# Access Compliance Report

## Public Rights-of-Way (Curb Ramps)

Intersection ID: 27325	Main Street: TILLEY MORRIS RD	Cross Street: N/A	Location: N
ADA ID: 9602E4C9A29E	Ramp Type: Directional1	Initial Pass/Fail: Fail	Overall Compliance: No
		Severity Score: 1.25

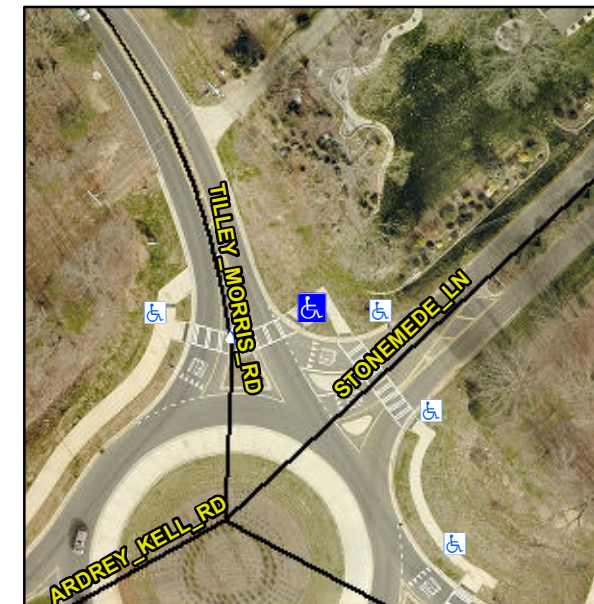
**R304.5.3**

Compliance	Description	Data	Compliance	Description	Data
N/A	Ramp Length (in)	100.0	N/A	Grade Break?	N/A
Yes	Ramp Width (in)	135.0	N/A	Grade Break Slope (%)	0.0
Yes	Ramp Slope (%)	3.3	N/A	Grade Break XSlope (%)	0.0
No	Ramp XSlope (%)	3.4			
N/A	Flare Type LT	N/A	N/A	Flare Type RT	N/A
N/A	Flare Slope LT (%)	N/A	N/A	Flare Slope RT (%)	0.0
N/A	Flare Traversable LT?	N/A	N/A	Flare Traversable RT?	N/A
N/A	Landing Length (in)	0.0	N/A	DWS Provided?	N/A
N/A	Landing Width (in)	0.0	N/A	DWS Contrast?	N/A
N/A	Landing Slope (%)	0.0	N/A	DWS Length (in)	N/A
N/A	Landing X Slope (%)	0.0	N/A	DWS Full Width?	N/A
N/A	Landing Curb? (Y/N)	N/A	N/A	DWS Offset LT (in)	N/A
N/A	Shared Landing?	N/A	N/A	DWS Offset RT (in)	N/A
N/A	Gutter Ponding?	0.0	N/A	Gutter Slope (%)	N/A
N/A	Gutter Lip Ht (in)	0.0	N/A	Gutter X Slope (%)	N/A
N/A	Painted X Walk1?	Yes		Road Slope (%)	2.8
	X Walk 1 Direction	To W		Road X Slope (%)	1.5
	X Walk 1 Width (in)	112.0		Clear Space?	N/A

**Remove & Replace Entire Ramp.**
